DEVELOPMENT REVIEW COMMITTEE (DRC) COMMENT REPORT

Project Name: PHD Development, LLC / Coconut Grove

Case Number: R15018

Request: Site Plan Level III Review: Ten (10) Unit Cluster Development

SP-1

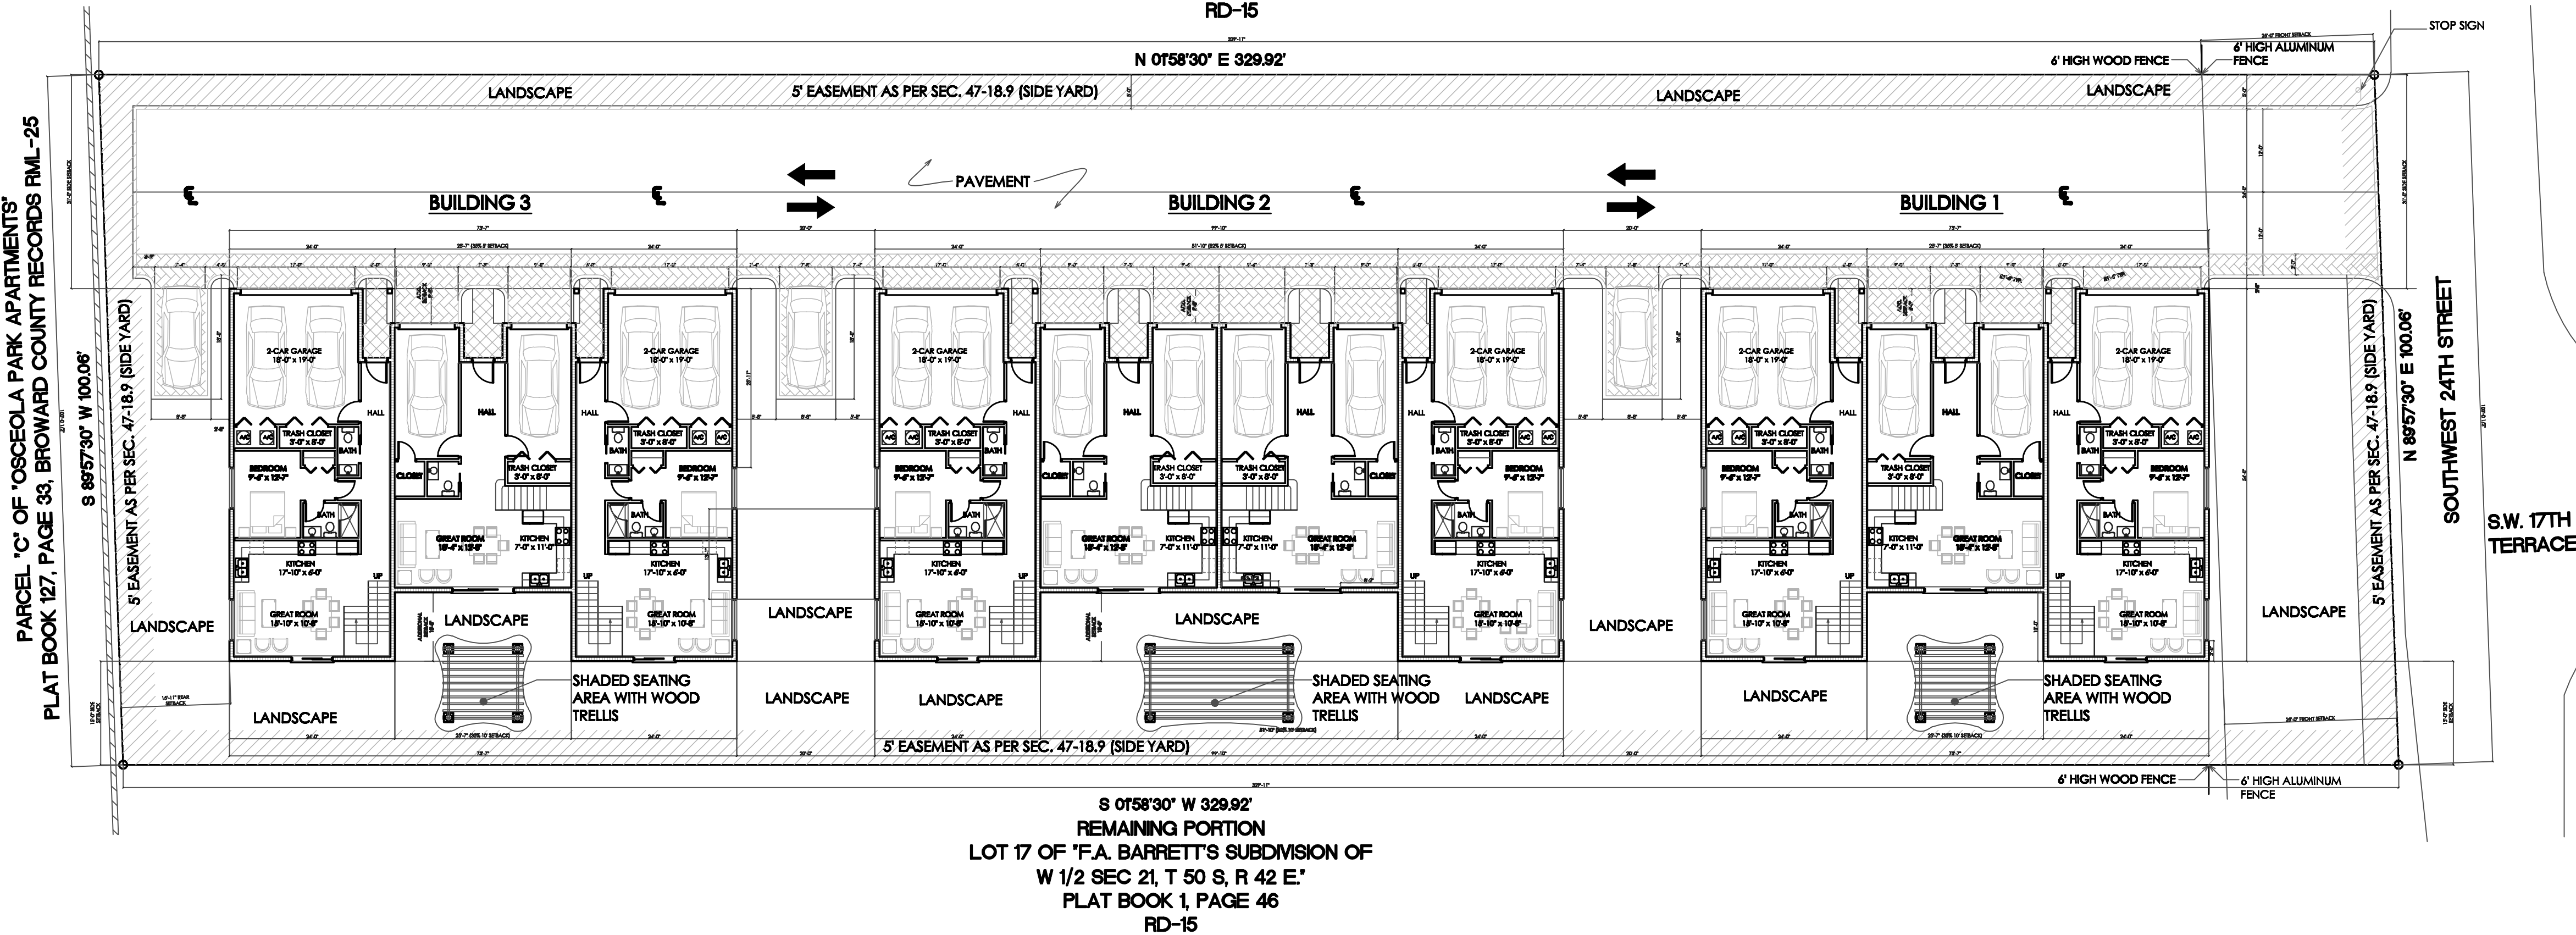
11. For legibility, show larger text size/arrows on Site Plan (SP-1).
12. Please prepare and submit the following exhibits which clearly define the following (as applicable):
